SPARTAN CHASSIS, INC.

TSB06-110-001A

TECHNICAL SERVICE BULLETIN

SUBJECT: Cab Doors - Front

FIG. 2-1

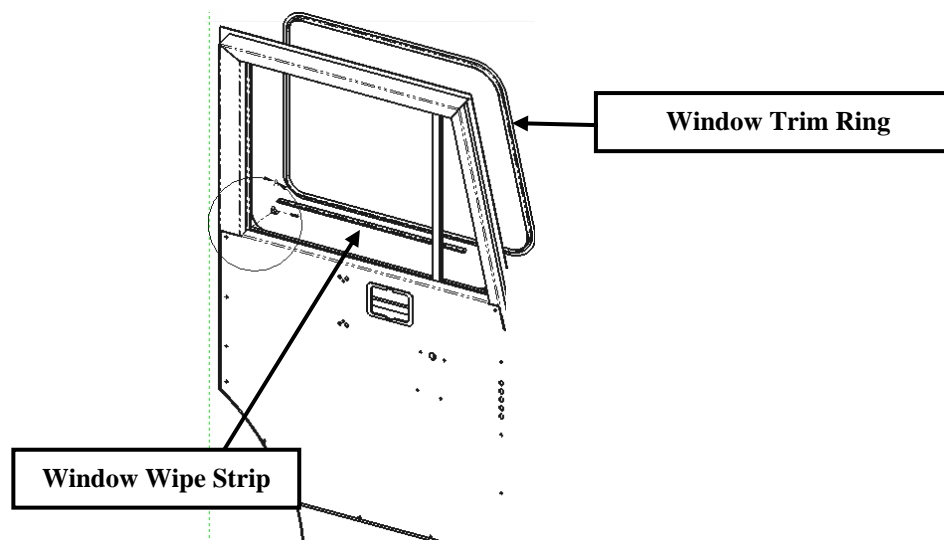
2. Refer to FIG.2-1. Disassemble black window trim ring from outside of one front door by removing (8) screws. Retain window trim and screws for reuse. Remove rubber window wipe strip and discard.
3. Refer to FIG. 3-1. Remove film from double sided tape on gusset and firmly place where shown. Tape side down to upper door support, keeping adjacent against inside of door frame.

FIG. 3-1

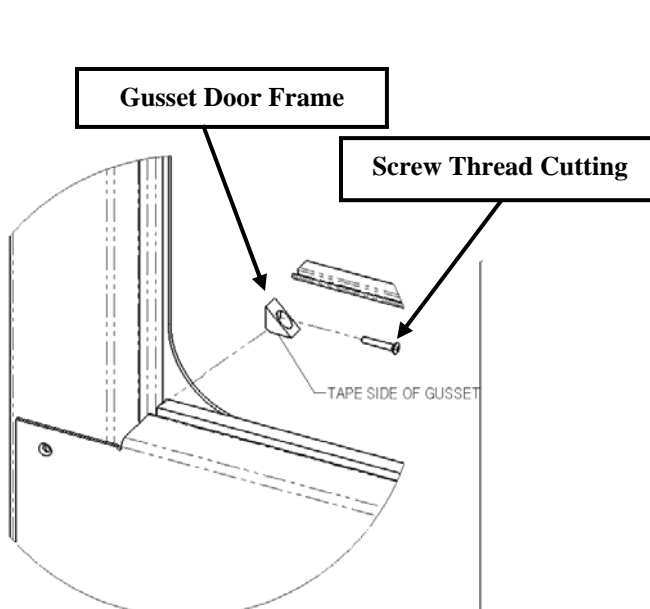
Note: Do not allow gusset to protrude into window track area.

4. Using the gusset as a guide, drill (1) .144 diameter hole into side door frame for self threading screw.

FIG. 3-2

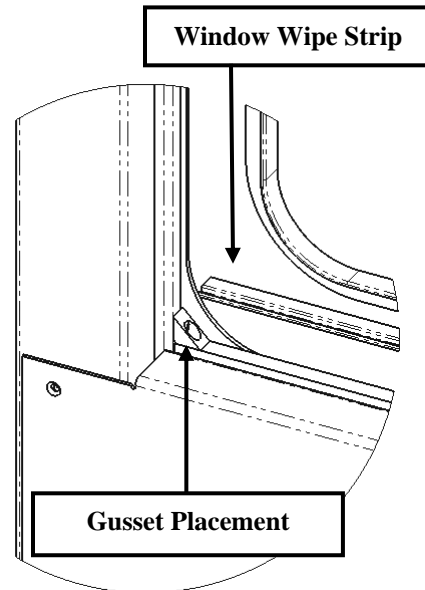
5. Refer to FIG. 3-2. Firmly attach gusset using screw from kit.
6. Reattach new window wipe strip along door upper support riding up onto newly attached gusset.

Caution: Do not allow window wipe strip to extend into window track area.
